SIB 65 18 20

SERVICE ACTION: HEAD AIR BAG HOLDER RETROFIT

E-Series	Model Description	Production Date
E46	323i, 328i 3 Series Sedan	September 1998 thru October 1998

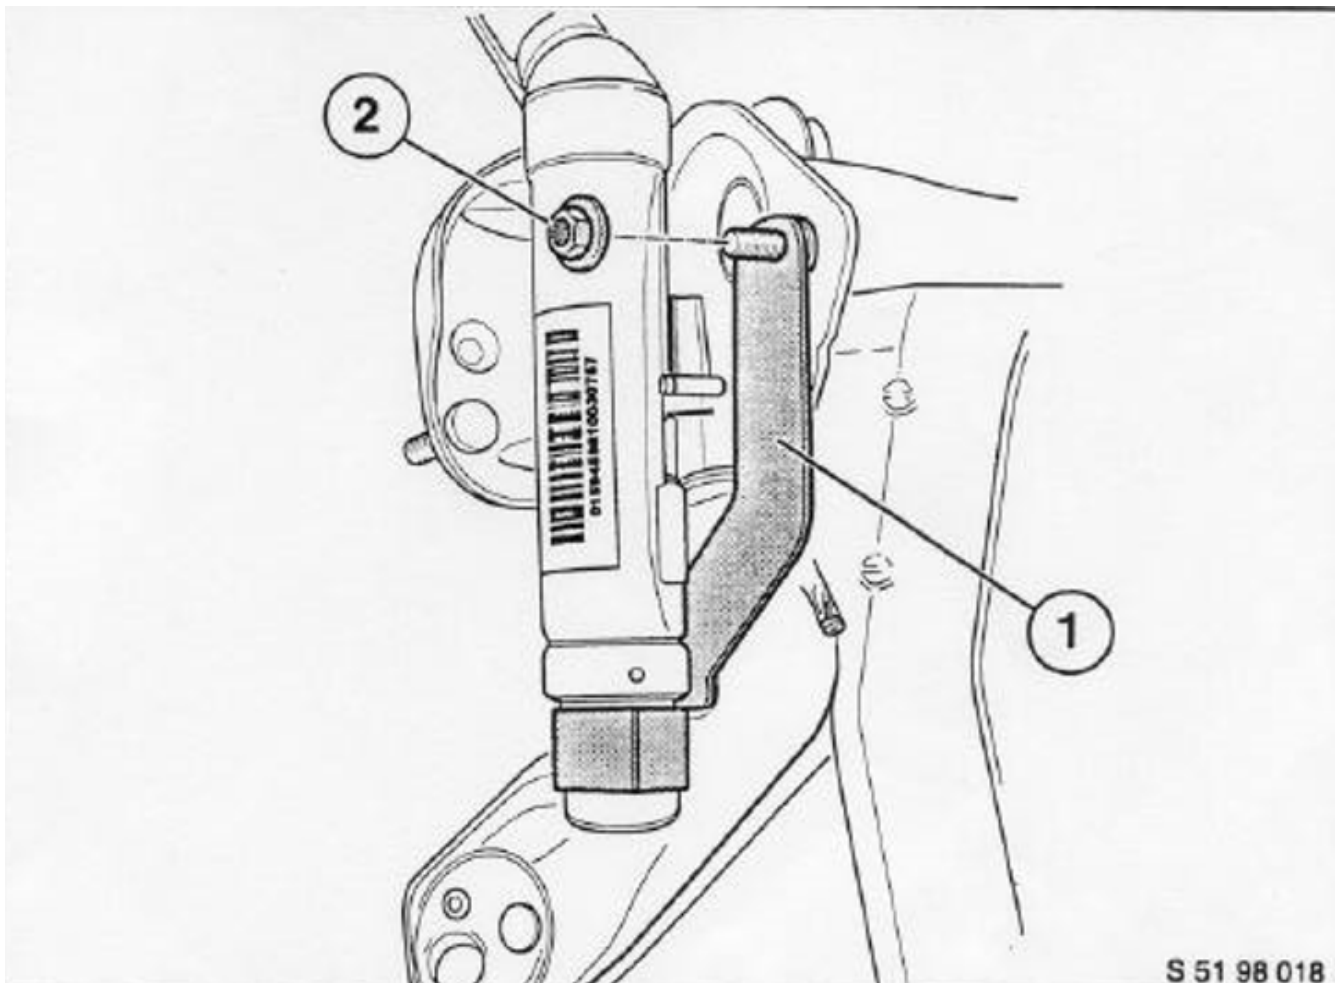
A rattle noise may develop from the head air bag (ITS) gas generator contacting adjacent component. This noise can be heard while driving on an uneven roadway.

This is due to the tight installation tolerance between the gas generators of the ITS head air bags and adjacent components.

An additional retrofit bracket (1) has been created to be installed on both ITS head air bags.

A new locking nut (2) will be used to retain the retrofitted bracket.

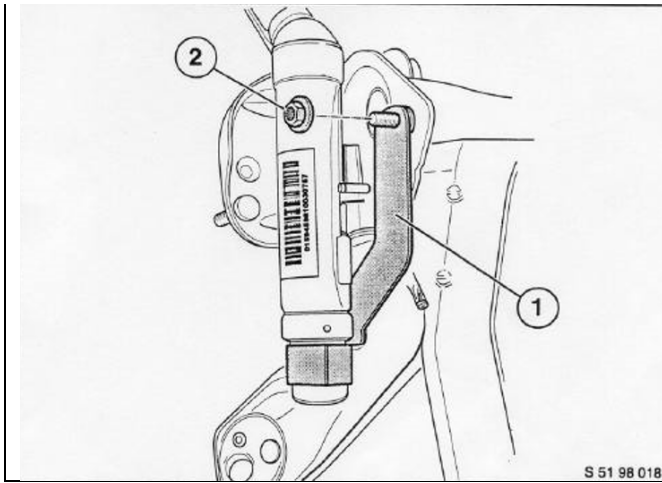
11. Retrofit the new bracket onto the existing ITS gas generator.

Attach the bracket (1) to the bottom of the gas generator and screw it into the attachment of the gas generator with a new self-locking hex (2) nut 07 14 7 153 450.
